2021 Design Competition Frequently Asked Questions

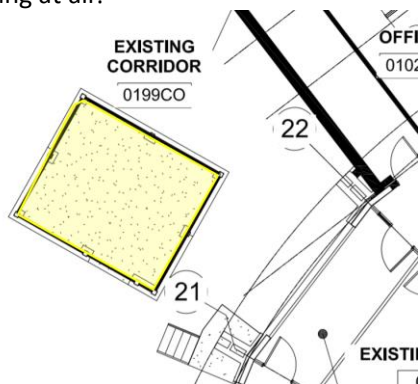
Q: Regarding the lower floor plans what is the unmarked square near the circled "21". Is it attached to the building at all?

A: Concrete slab located outside

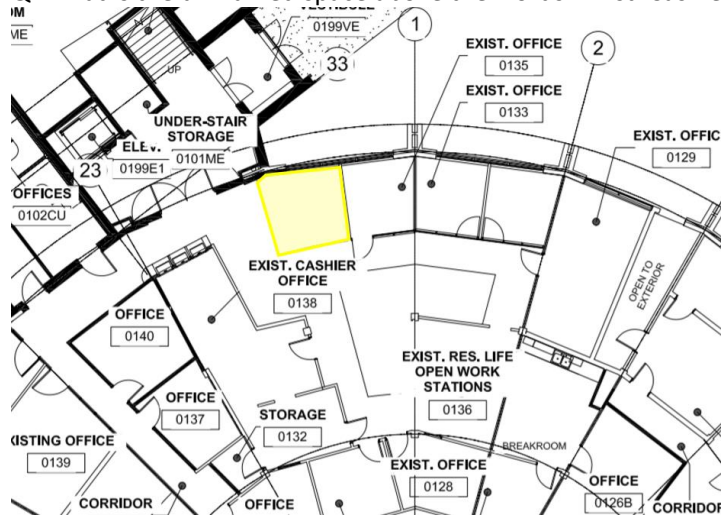
Q: What is the unmarked space above the words "Exist. Cashier Office"?

A: It is part of the "Exist. Res. Life Open Work Stations". The line was an extension of the previously marked "circled 24" – it is supposed to be erased.

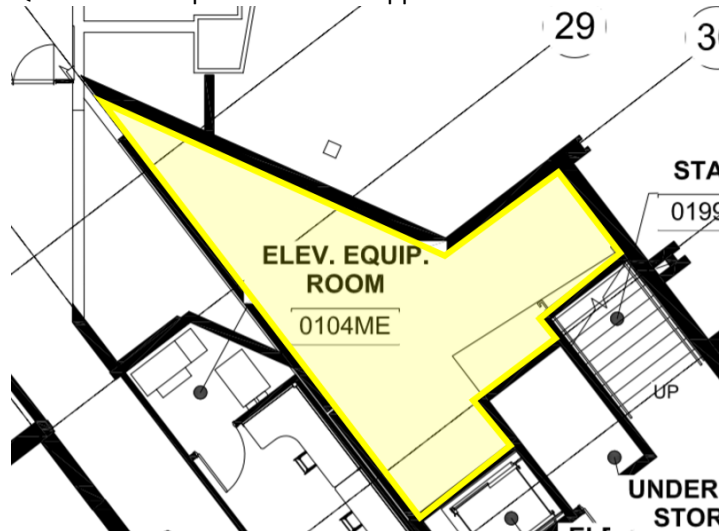
Q: What is the space above the upper stairs near the circled "30", is it just a corridor?

A: Entrance hallway from an adjacent building. You could treat it as an exterior entrance if you would like. So yes, a corridor is appropriate.

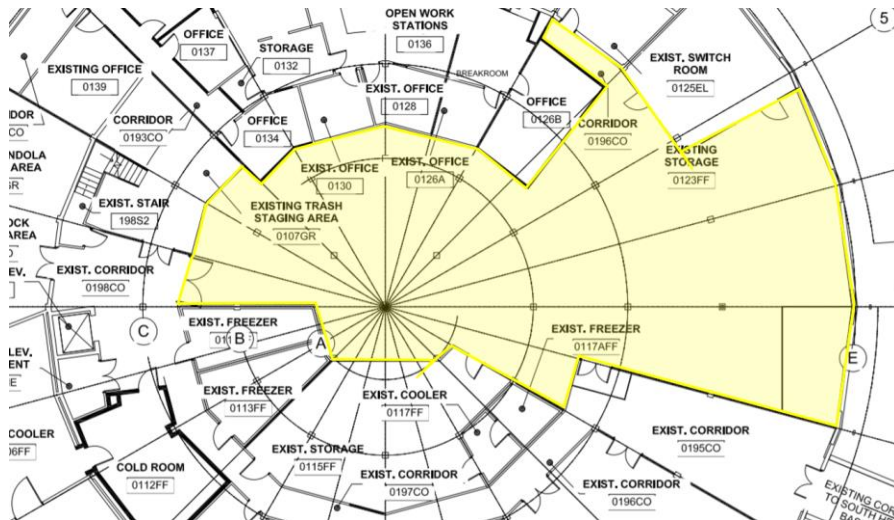
Q: What is the space at the center of the floor plan?

Q: It appears to be labelled as "Existing Storage [0123FF]", or is the label referring to the room just above the label?

A: It is open space

A: Existing Storage "0123FF" is for the room above the label.
